Title: Twynyrodyn, Merthyr Tydfil – Transport Assessment Audit

Date: 2nd December 2021

Prepared For: Merthyr Tydfil County Borough Council

Ref: CS/100364 / Technical Note TN2

Figure 4.3: Pedestrian access to Aneurin Crescent - Extract

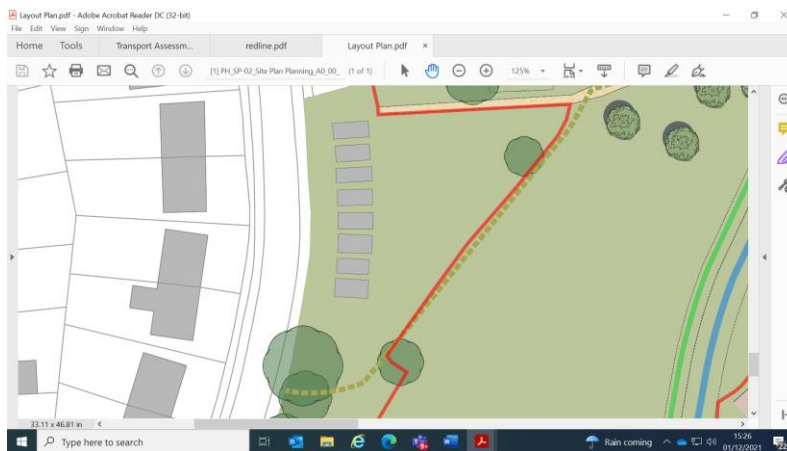
Three accesses onto Aneurin Crescent are proposed in Figure 4.3. However, these pedestrian accesses to Aneurin Crescent with tarmac / rolled chippings on the links does not reflect layout drawing SP-02-Rev00 and Figure 4.1.

In addition to the form of construction, the widths of these links require confirmation as they look variable in Figure 4.3.

Of the three links in Figure 4.3 providing access to Aneurin Crescent and the associated bus stop, only one is a public right. All the routes are unpaved and unlit, creating further concerns regards personal safety and use, especially at night.

Figure 3.4: Public Rights of Way network in the vicinity of the site - Extract

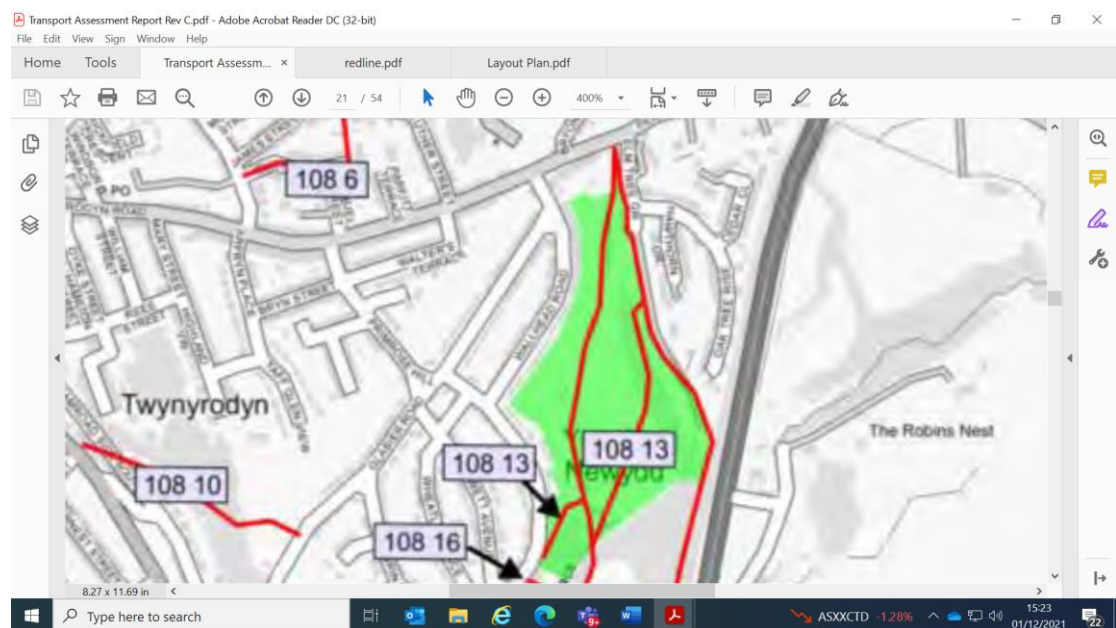
Figure 3.4 identifies two public rights of way through the site and a third on the eastern boundary.

On Drawing SP-02-Rev00 one of these rights of way is missing, although there is a solid green line which is not represented within the key.

With regards to these routes, paragraph 4.3.1 states: *‘These routes will be retained and incorporated within the scheme, providing a permeable development, that will allow pedestrians and cyclists to progress through the site, as well as allow pedestrians and cyclists to access the development.’* Confirmation to the width and construction of these routes is required.

Figure A1: Active Travel Map - Extract

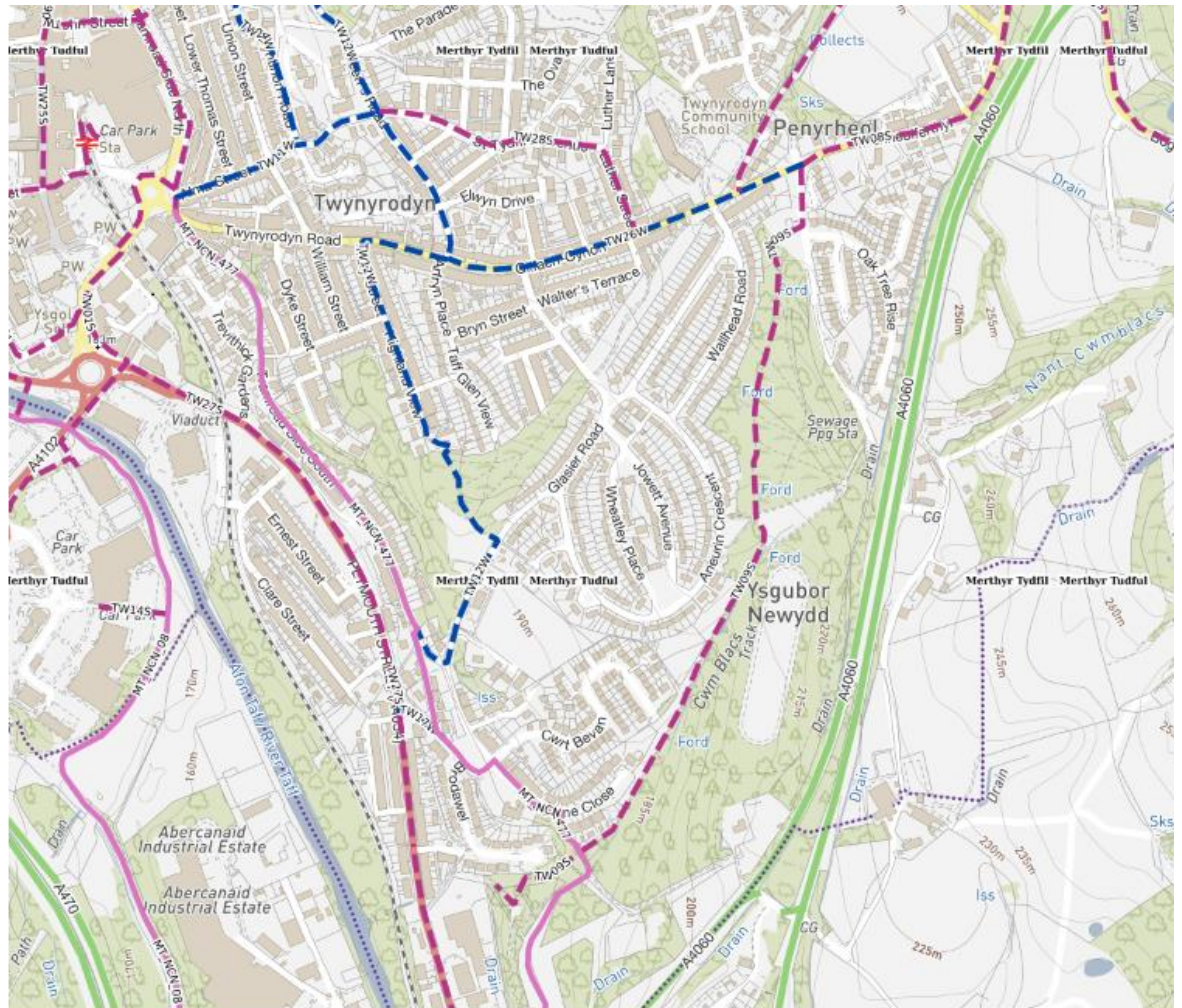
A review of the active travel proposals for Merthyr Tydfil identifies that shared use route TW09S, which has yet to be approved, is proposed through the site. Details of how this will be provided for within the site in terms of widths and construction should be provided. There should also be contributions to active travel provision outside of the redline boundary.
